Product Change Notice

PCN#: EE-PCN16010

Part marking change.

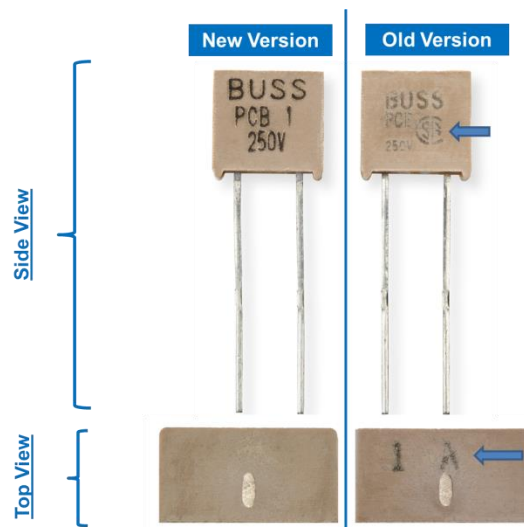
- (a). CSA marking removed
- (b). Amp marking moved from top side of product to the front side
